Relevant Representations to the Whitestone Solar Farm Development Consent Order

Application: EN0110020

Rotherham Metropolitan Borough Council

Whitestone Solar Farm DCO Relevant Representations
Rotherham Metropolitan Borough Council

Figure 1: SL-01 Indicative Location

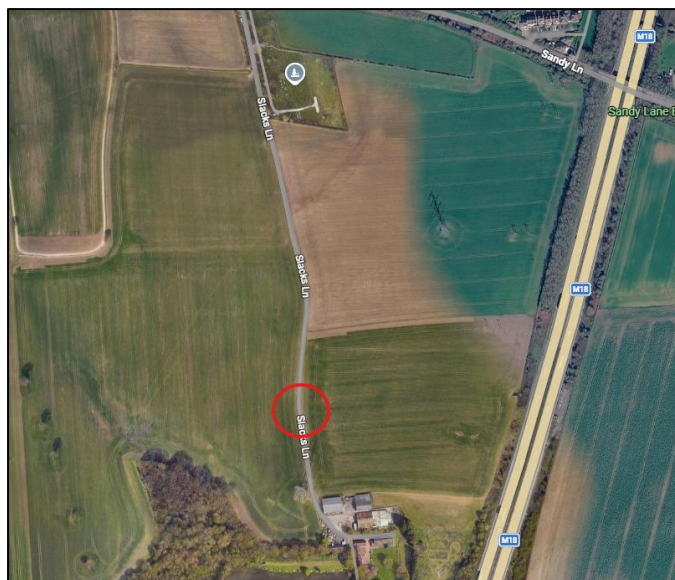
Road Status	
Adopted / Unadopted	Adopted (forms part of the public adopted highway)
Speed Limit	30mph
Applicant's Proposal	
Proposed Visibility Splay	90m to the north and south (DMRB Desirable Minimum SSD compliant for a 30mph speed limit)
Access / Crossing	Access (PV Area)
Existing / New Access	New access along the western highway boundary.
Daily Vehicle Access	Estimated 13 HGVs and 32 staff vehicles.
Stantec's Comments	
Horizontal Visibility	Horizontal visibility is achievable , subject to the minor removal of vegetation on the western highway boundary to the south. Street View imagery indicates that, in the vicinity of the proposed access, the road is generally straight with minor horizontal curvature to the north. No horizontal constraints to the achievement of the proposed visibility splay have been identified from available imagery.
Vertical Visibility	Vertical visibility is achievable . Street View imagery indicates that, in the vicinity of the proposed access, the road is generally level with no significant crests. No vertical constraints to the achievement of the proposed visibility splay have been identified from available imagery.

Figure 2: SL-02 Indicative Location

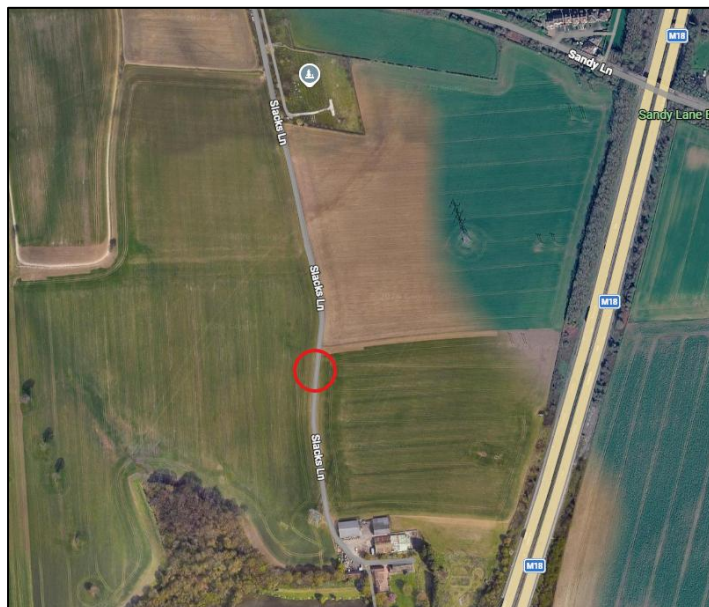
Passing Place	A viable passing place will be required along Slacks Lane accounting for the existing width of the carriageway.

Figure 3: SEL-01 Indicative Location

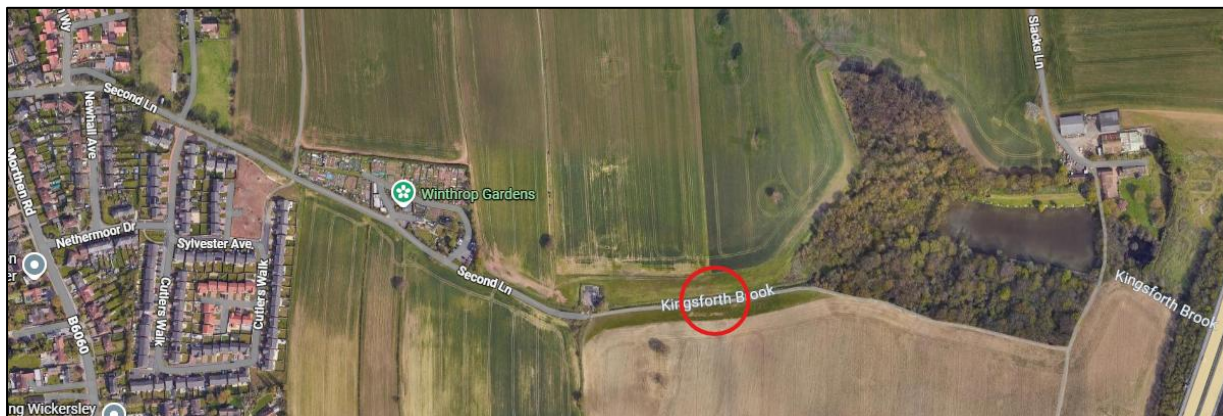
Vertical Visibility Southern Access	Vertical visibility is achievable . Limited Street View imagery is available; however, in the vicinity of the proposed access, the road appears generally level with no significant crests. No vertical constraints to the achievement of the proposed visibility splay have been identified from available imagery.
--	---

Figure 6: CCL-01 Indicative Location

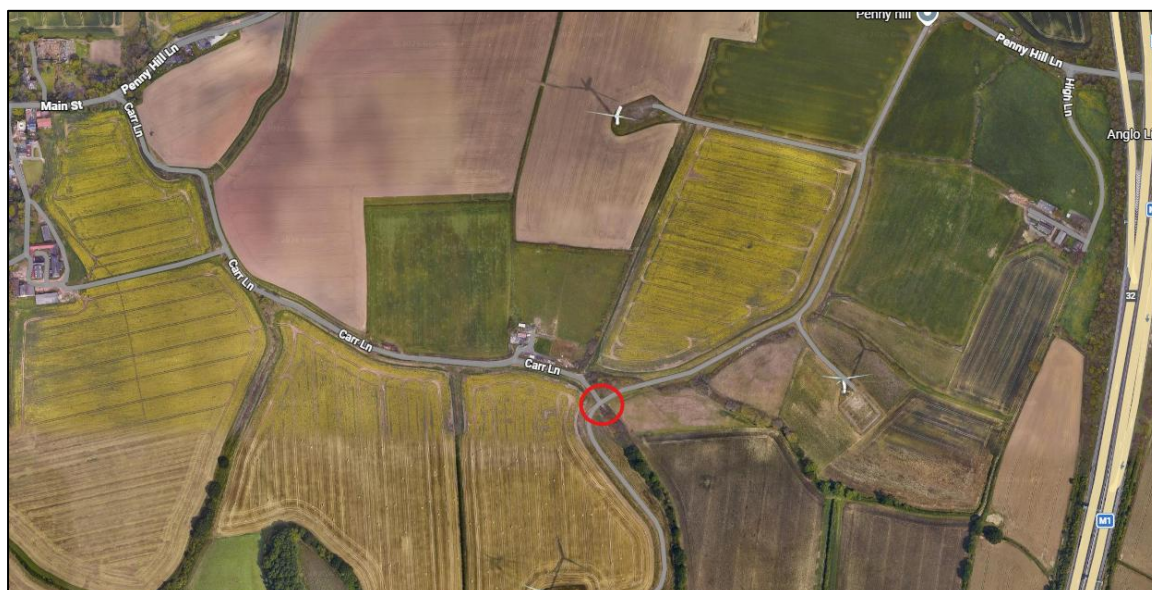
Horizontal Visibility Western Access	Horizontal visibility is achievable , subject to the minor removal of vegetation on the western highway boundary to the southeast and significant removal of vegetation and hedgerow on the western highway boundary to the northwest. No Street View imagery is available; however aerial imagery indicates that, in the vicinity of the proposed access, the road appears generally curved, with significant horizontal curvature to the northwest. Further to a site visit, it was observed that no horizontal constraints to the achievement of the proposed visibility splay are present. However, it is recommended that the visibility splay to the tangent is also demonstrated on the drawing to further confirm achievement of the proposed visibility splay.
Vertical Visibility Western Access	Vertical visibility is achievable . No Street View imagery is available. Further to a site visit, it was observed that no vertical constraints to the achievement of the proposed visibility splay are present.

Figure 7: CUL-01 Indicative Location

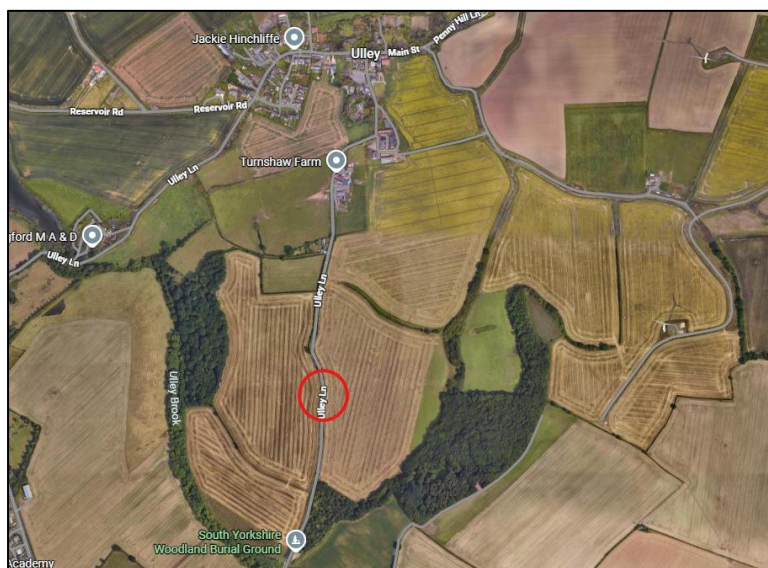
Horizontal Visibility Western Access	Horizontal visibility is achievable , subject to the significant removal of vegetation and hedgerow on the eastern highway boundary to the north and minor removal of vegetation on the western highway boundary to the south. Street View imagery indicates that, in the vicinity of the proposed access, the road is generally curved with significant horizontal curvature to the north and south. No horizontal constraints to the achievement of the proposed visibility splay have been identified from available imagery. However, it is recommended that the visibility splay to the tangent is also demonstrated on the drawing to further confirm achievement of the proposed visibility splay.
Vertical Visibility Western Access	Vertical visibility is achievable . Street View imagery indicates that, in the vicinity of the proposed access, the road generally follows a north-south gradient, rising towards the north and falling towards the south, with no significant crests. No vertical constraints to the achievement of the proposed visibility splay have been identified from available imagery.

Figure 8: PEHL-02 Indicative Location

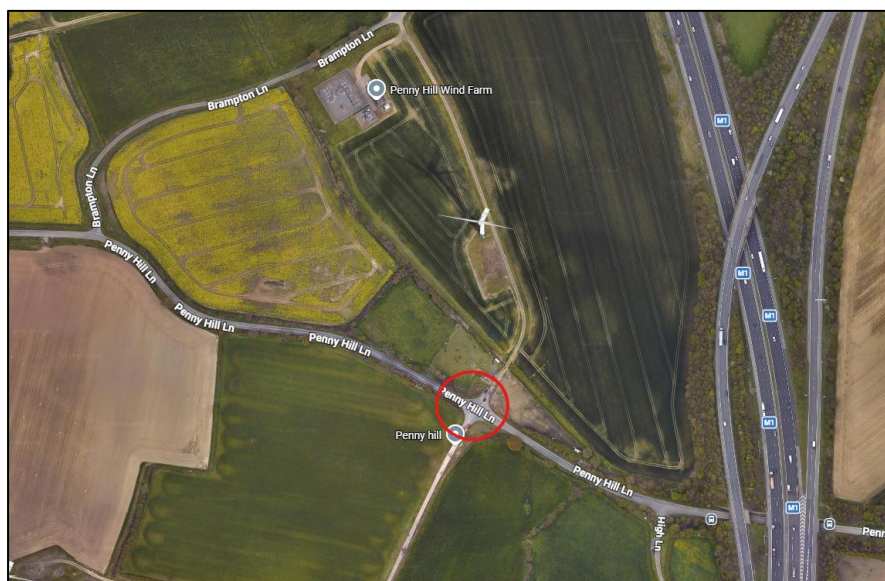
Vertical Visibility	Vertical visibility is achievable . Street View imagery indicates that, in the vicinity of the proposed access, the road is generally level with no significant crests. No vertical constraints to the achievement of the proposed visibility splay have been identified from available imagery.

Figure 9: PEHL-03 Indicative Location

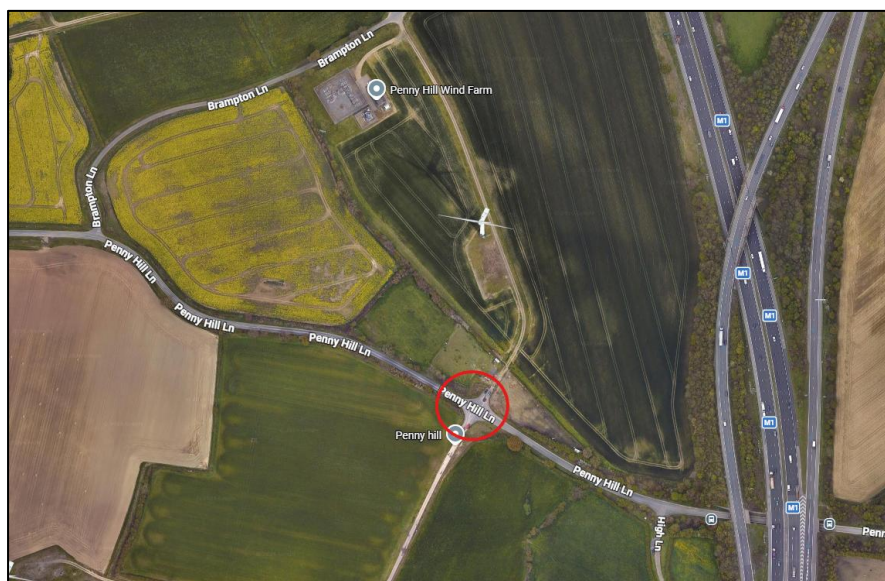
Vertical Visibility	Vertical visibility is achievable . Street View imagery indicates that, in the vicinity of the proposed access, the road is generally level with no significant crests. No vertical constraints to the achievement of the proposed visibility splay have been identified from available imagery.

Figure 20: CC-11 Indicative Location

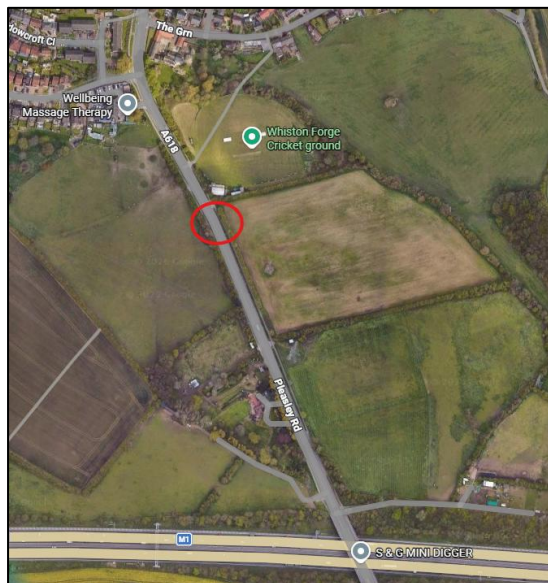
Road Status	
Adopted / Unadopted	Adopted (forms part of the public adopted highway)
Speed Limit	50mph
Applicant's Proposal	
Proposed Visibility Splay	160m to the north and south (DMRB Desirable Minimum SSD compliant for a 50mph speed limit)
Access / Crossing	Access (Cable Corridor Area)
Existing / New Access	New access required along the eastern highway boundary.
Daily Vehicle Access	Estimated 6 HGVs and 10 staff vehicles.
Stantec's Comments	
Horizontal Visibility	Horizontal visibility is achievable , subject to the minor removal of vegetation on the eastern highway boundary to the north and south. Street View imagery indicates that, in the vicinity of the proposed access, the road is generally straight to the south, with minor horizontal curvature to the north. Further to a site visit, it was observed that no horizontal constraints to the achievement of the proposed visibility splay are present.
Vertical Visibility	Vertical visibility to the north is achievable. However, further to a site visit, it was observed that vertical visibility to the south is not achievable . Street View imagery indicates that, in the vicinity of the proposed access, the road generally follows a north-south gradient, falling towards the north and rising towards the south, with a notable blind crest located to the south.

Figure 21: CC-13 Indicative Location

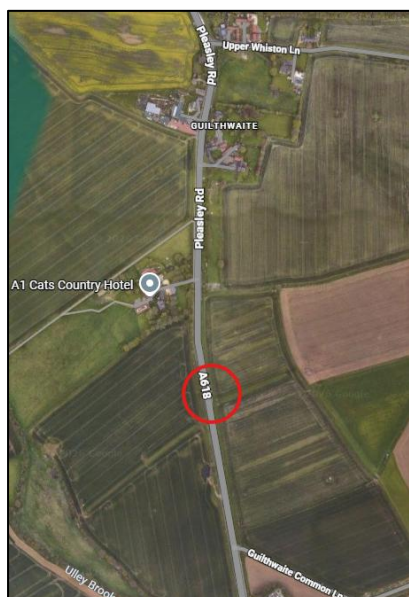
Vertical Visibility	Vertical visibility to the north is achievable . However, further to a site visit, it was observed that vertical visibility to the south is not achievable . Street View imagery indicates that, in the vicinity of the proposed access, the road generally follows a north-south gradient, falling towards the north and rising towards the south, with a notable blind crest located to the south.

Figure 22: CC-14 Indicative Location

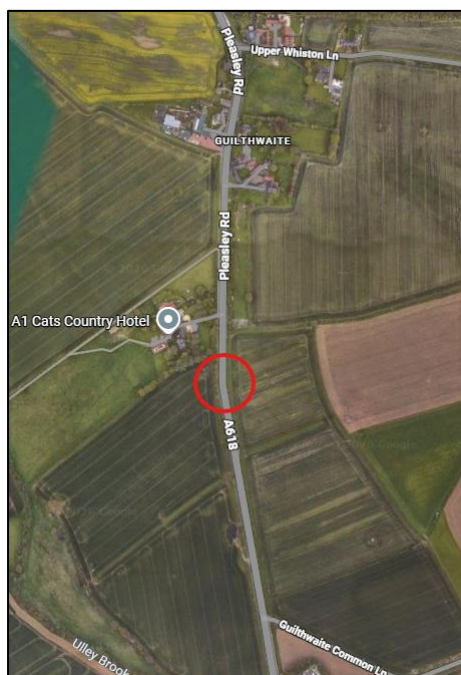
Road Status	
Adopted / Unadopted	Adopted (forms part of the public adopted highway)
Speed Limit	60mph
Applicant's Proposal	
Proposed Visibility Splay	215m to the north and south (DMRB Desirable Minimum SSD compliant for a 60mph speed limit)
Access / Crossing	Access (Cable Corridor Area)
Existing / New Access	New access along the western highway boundary.
Daily Vehicle Access	Estimated 24 HGVs and 36 staff vehicles.
Stantec's Comments	
Horizontal Visibility	Horizontal visibility is achievable , subject to the minor removal of vegetation on the western highway boundary to the north and south. Street View imagery indicates that, in the vicinity of the proposed access, the road is generally straight with no significant horizontal curvature. Further to a site visit, it was observed that no horizontal constraints to the achievement of the proposed visibility splay are present.
Vertical Visibility	Vertical visibility is achievable . Street View imagery indicates that, in the vicinity of the proposed access, the road generally follows a north-south gradient, falling towards the north and rising towards the south, with a notable crest located to the south. Further to a site visit, it was observed that no vertical constraints to the achievement of the proposed visibility splay are present.

Figure 23: POHL-02 Indicative Location

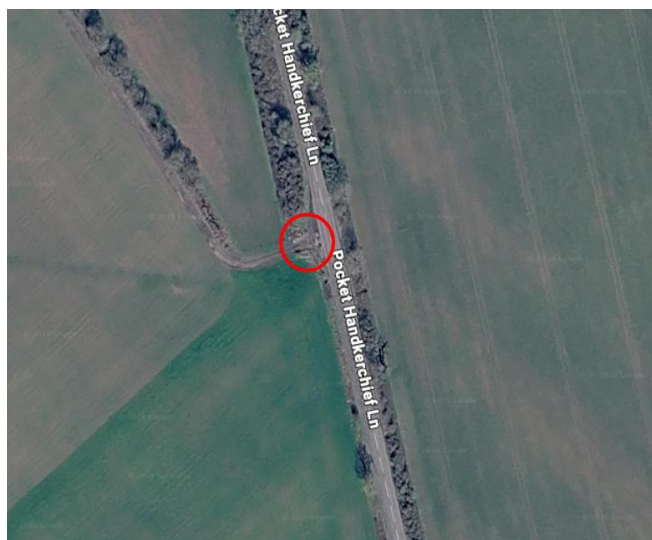
Vertical Visibility	Vertical visibility is achievable . Street View imagery indicates that, in the vicinity of the proposed access, the road is generally level with no significant crests. No vertical constraints to the achievement of the proposed visibility splay have been identified from available imagery.

Figure 27: CC-P2 Indicative Location

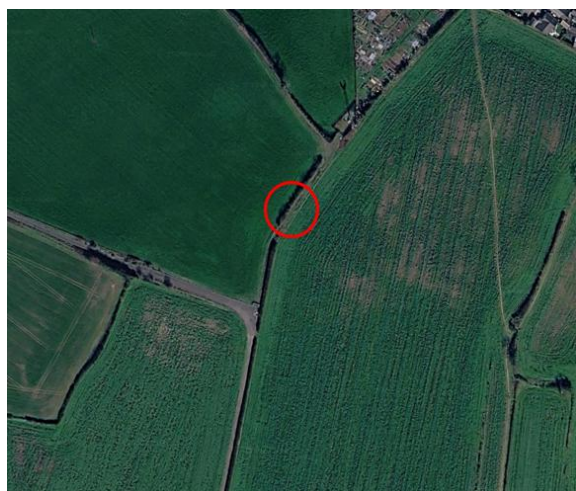
Note: On the proposed access drawing, the eastern access is labelled as the southern access and the western access is labelled as the northern access.

Figure 28: CC-P3 Indicative Location

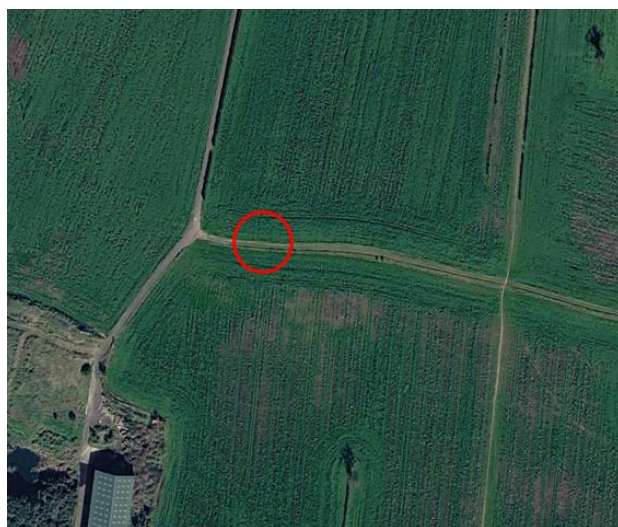
Horizontal Visibility Southern Access	Horizontal visibility is achievable , subject to the minor removal of vegetation on the southern highway boundary to the east and west. No Street View imagery is available; however aerial imagery indicates that, in the vicinity of the proposed access, the road appears generally straight, with no significant horizontal curvature. No horizontal constraints to the achievement of the proposed visibility splay have been identified from available imagery.
Vertical Visibility Southern Access	It is unknown if vertical visibility is achievable. No Street View imagery is available. The proposed crossing is located on an unadopted private road with gated accesses from Dog Kennels Hill.

Figure 29: CC-25 Indicative Location

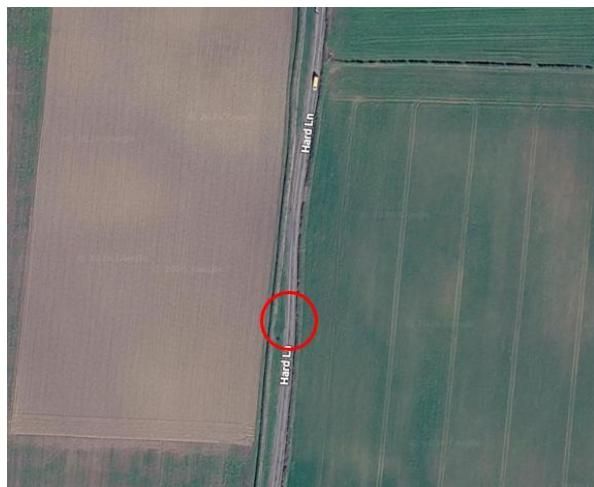
Road Status	
Adopted / Unadopted	Adopted (forms part of the public adopted highway)
Speed Limit	60mph
Applicant's Proposal	
Proposed Visibility Splay	215m to the north and south (DMRB Desirable Minimum SSD compliant for a 60mph speed limit)
Access / Crossing	Access (Cable Corridor Access)
Existing / New Access	New access along the eastern highway boundary.
Daily Vehicle Access	Estimated 44 HGVs and 66 staff vehicles.
Stantec's Comments	
Horizontal Visibility	Horizontal visibility is achievable , subject to the minor removal of vegetation and hedgerow on the eastern highway boundary to the north and south. Street View imagery indicates that, in the vicinity of the proposed access, the road is generally straight with no significant horizontal curvature. Further to a site visit, it was observed that no horizontal constraints to the achievement of the proposed visibility splay are present.
Vertical Visibility	Vertical visibility to the south is achievable . However, further to a site visit, it was observed that vertical visibility to the north is not achievable . Street View imagery indicates that, in the vicinity of the proposed access, the road generally follows a north-south gradient, falling towards the south and rising towards the north, with a notable blind crest located to the north.

Figure 1: LL-01 Location

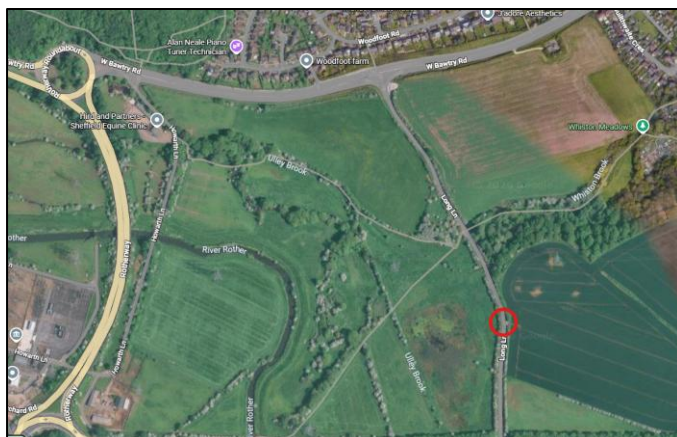
Road Spec	Speed Survey	Survey Vis Splay	Requirements	Access / Crossing
60mph – DMRB 215m desirable minimum SSD	47 mph	133m desirable minimum. 103m absolute minimum.	Reduced vis splay proposed.	Access

Figure 3: GCL-02 Location

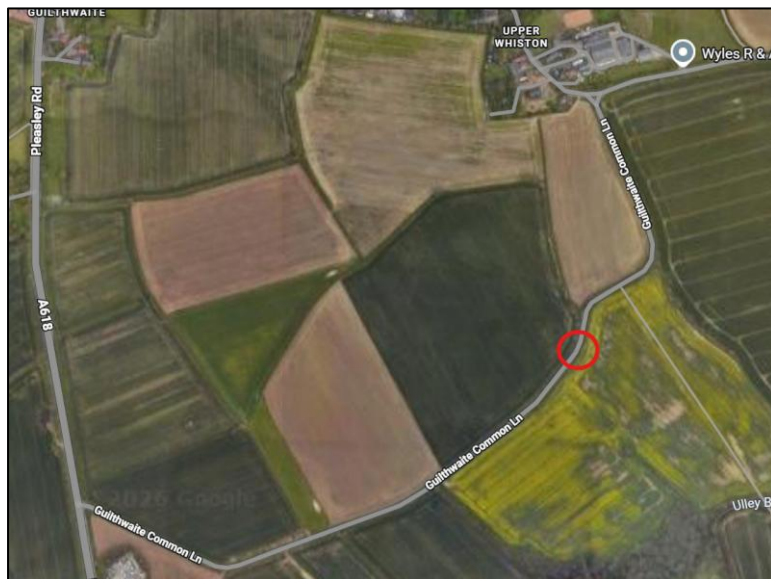
Road Spec	Speed Survey	Survey Vis Splay	Requirements	Access / Crossing
60mph – DMRB 215m desirable minimum SSD	43 mph	113m desirable minimum. 88m absolute minimum.	Reduced vis splay proposed.	Access

Figure 86: CC-23/24 Site Location

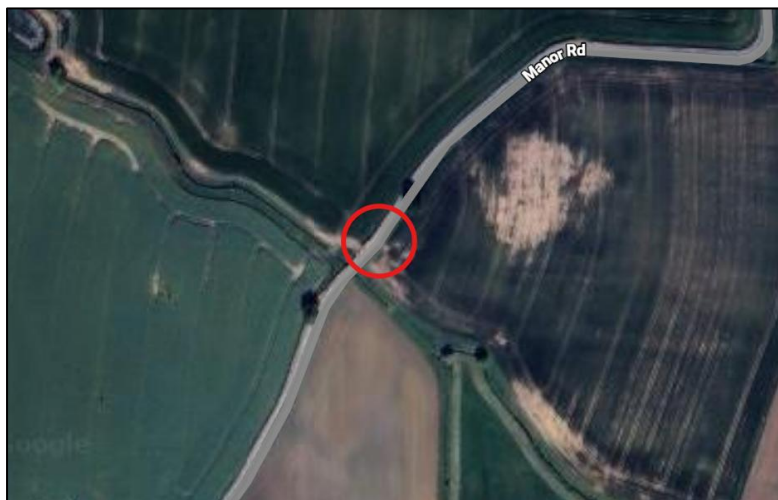
Road Spec	Speed Survey	Survey Vis Splay	Requirements	Access / Crossing
60mph – DMRB 215m desirable minimum SSD	n/a – 30mph temporary limit proposed	90m temporary speed limit	30mph vis splay proposed.	Crossing
